DOCKETS 50-266 AND 50-301
ADDITIONAL INFORMATION ON ECCS LOCA ANALYSIS
POINT BEACH NUCLEAR PLANT, UNITS 1 AND 2

On March 19, 1991 you telephoned Wisconsin Electric requesting additional information on the Emergency Core Cooling System (ECCS) large-break Loss of Coolant Accident (LOCA) analysis performed for Point Beach Nuclear Plant (PBNP). The additional information is needed to close out your review of recent changes to the analysis described in our letter dated March 5, 1991. This letter provides the information you requested.

Attachment 3 is a copy of changes to section 14.3.2 of the PBNP Final Safety Analysis Report. Section 14.3.2 is the section titled "Major Reactor Coolant System Pipe Ruptures (Loss-of-Coolant Accident)." Changes in the text are hand-written on the copy and the figures are revised based on the new analysis.

Figure 14.3.2-1. Comparison of Appendix K and Bounded Break Spectrums

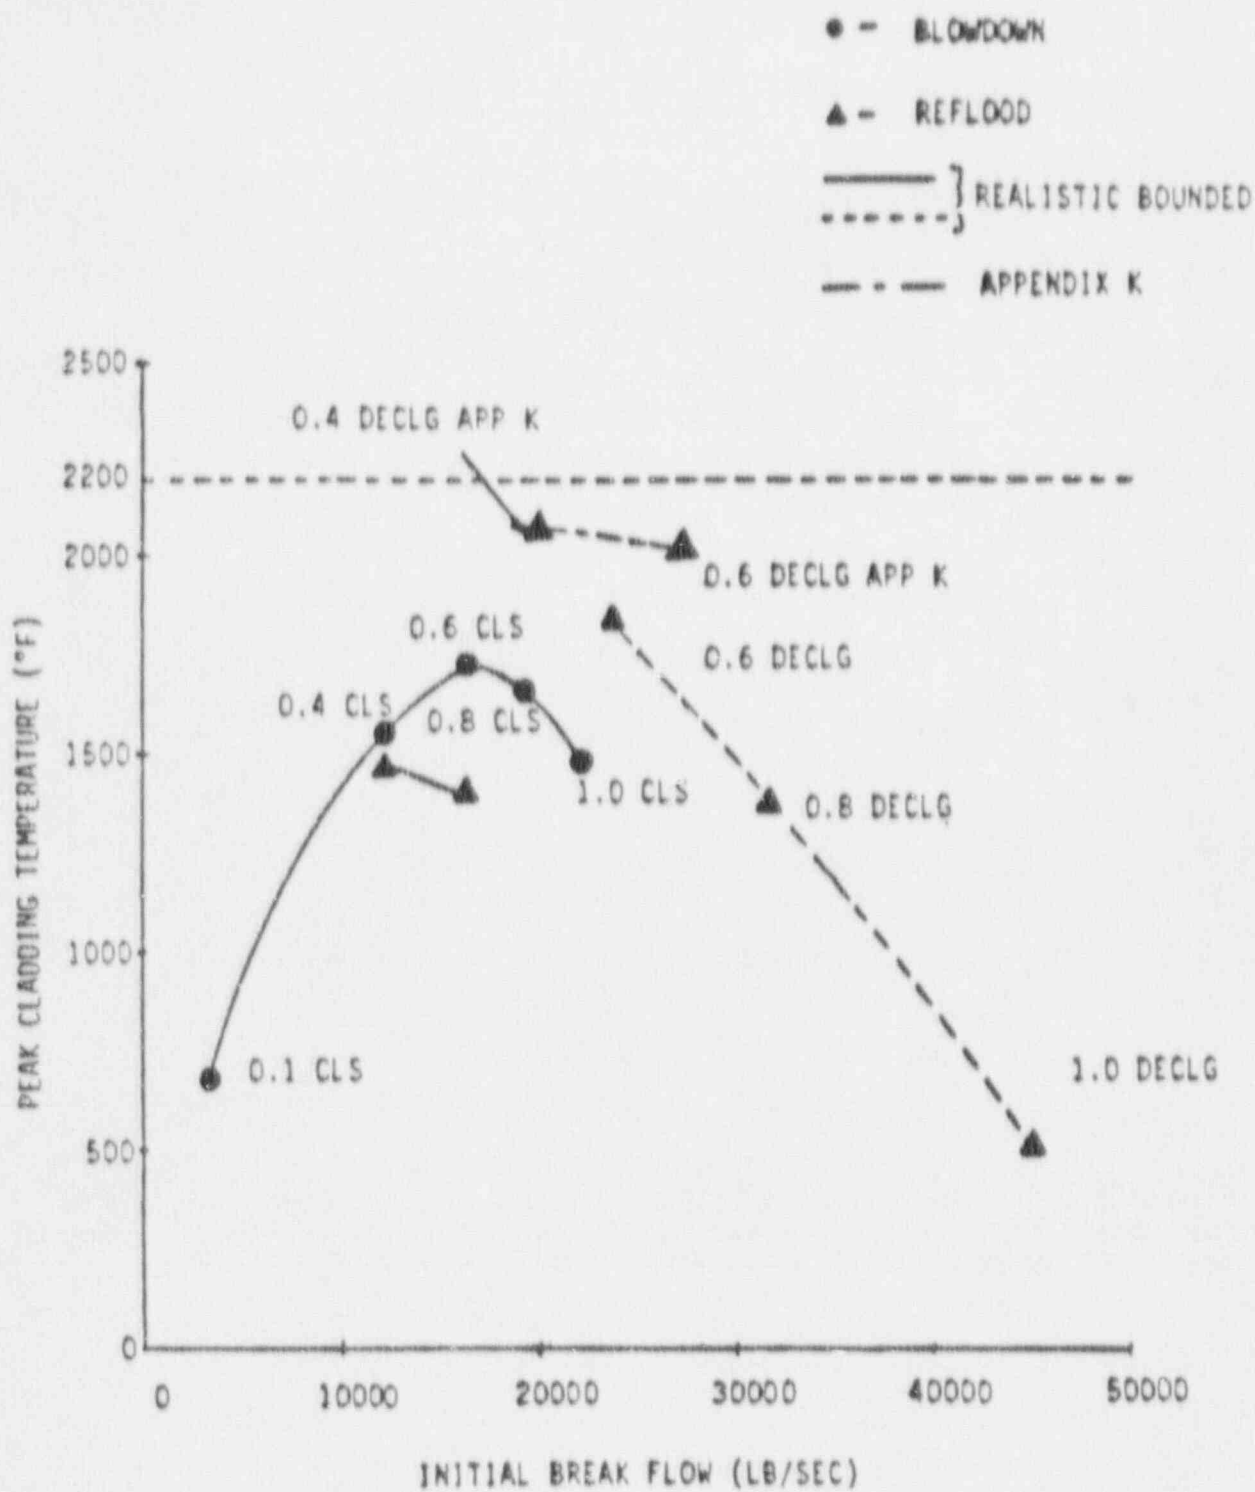
Studies were also performed to determine the limiting break type and the limiting break size. Figure 14.3.2-1 shows the results of these calculations, performed using the Prairie Island Nuclear Plant model. Cold Leg Split (CLS) breaks are defined as breaks formed in the wall of the cold leg such that flow must make a right angle turn to exit the break, such as would be formed if a pipe had a longitudinal crack. The Double-Ended Cold Leg Guillotine (DECLG) break is defined as the full severance of a

cold leg such that water spills out from both sides of break, with various discharge coefficients modeled to account for possible variations in flow. These results show a clear trend that a DECLG break with a discharge coefficient of 0.4 will be limiting for the Appendix K calculation. Double-Ended Hot Leg Guideline (DEHLG) break results are not shown in Figure 14.3.2-1. Calculations described in Reference 3 show that DEHLG breaks are not limiting. These results justify performing only a 0.4 DECLG break for the Point Beach Appendix K calculation, results of which will be discussed later.

Figure 14.3.2-9. Cladding Temperature History at PCT Location
 (2250 psia case) (0.4 DECIG)

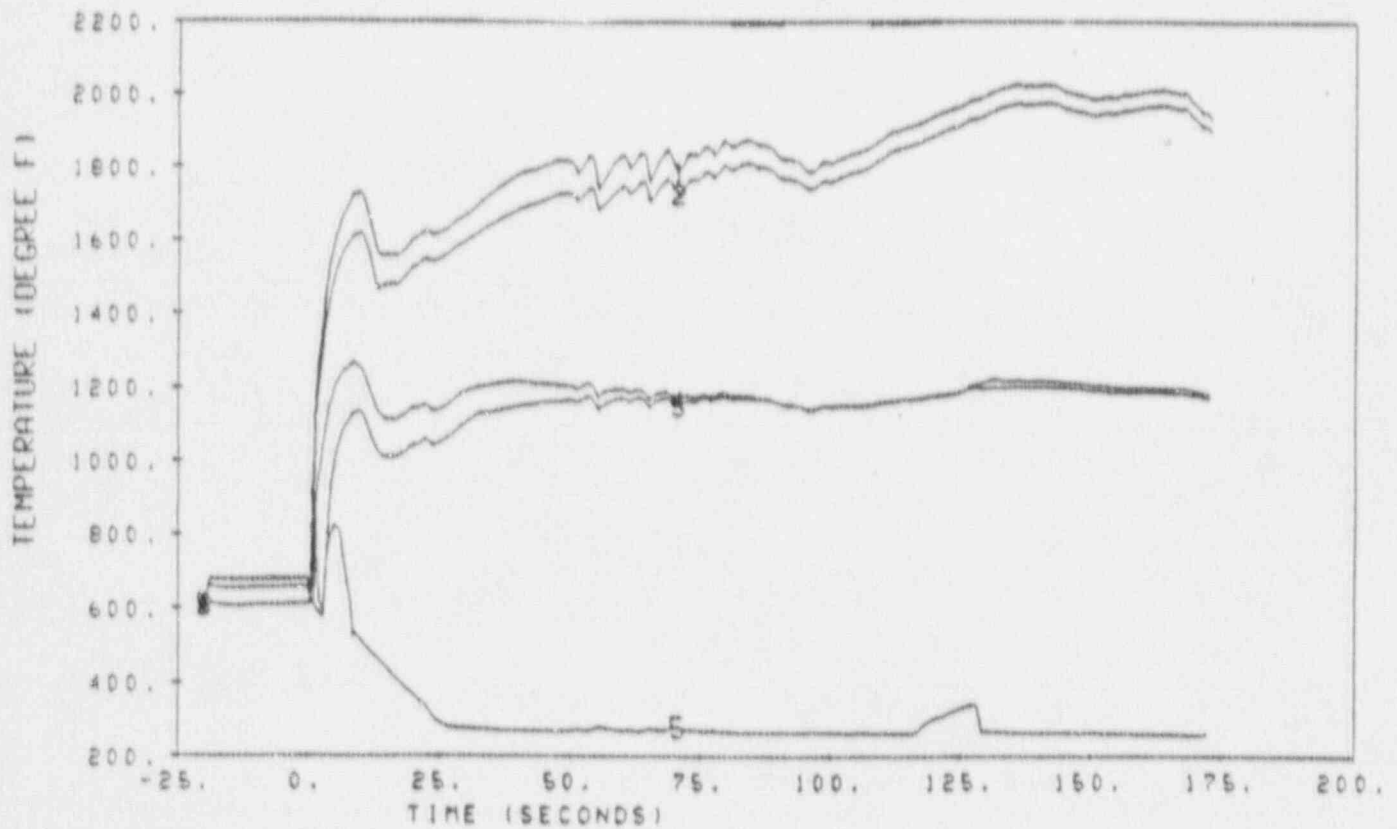
(accumulator and high head safety injection flow) with Figure 14.3.2-8 showing the flow of low head safety injection into the upper plenum (UPI flow). Figure 14.3.2-9 shows the resulting peak cladding temperature for the 0.4 DECLG break as a function of time for each of the five fuel rods modeled. Rod 1 is the hot rod in the hot assembly channel, Rod 2 is the hot assembly average rod, Rods 3 and 4 represent average assemblies in the center of the core and Rod 5 represents the lower power assemblies at the edge of the core at a value of 0.6 times the core average power. Figures 14.3.2-10 and 14.3.2-11 show the core power history for the blowdown period and for the complete transient. Figure 14.3.2-12 shows the containment pressure response as calculated by the COCO computer program. Figure 14.3.2-13 shows the mixture flow rate out of the vessel side of the broken cold leg. Positive flow is out of the vessel. Figure 14.3.2-14 shows the mixture flow rate, in LBM/SEC, out of the loop side of the broken cold leg. Positive flow is out of the cold leg. No flow is shown prior to time 0.0 seconds because the component being plotted is added at time 0.0 seconds to initiate the break.

The CD=0.4 break proved to be the limiting (highest predicted peak cladding temperature, PCT) case with a PCT of 202⁸°F for the four channel core model with 2250 psia system pressure. Previous sensitivity studies indicated that a 0.6 or 0.8 DECLG case would yield even lower temperatures. [3]
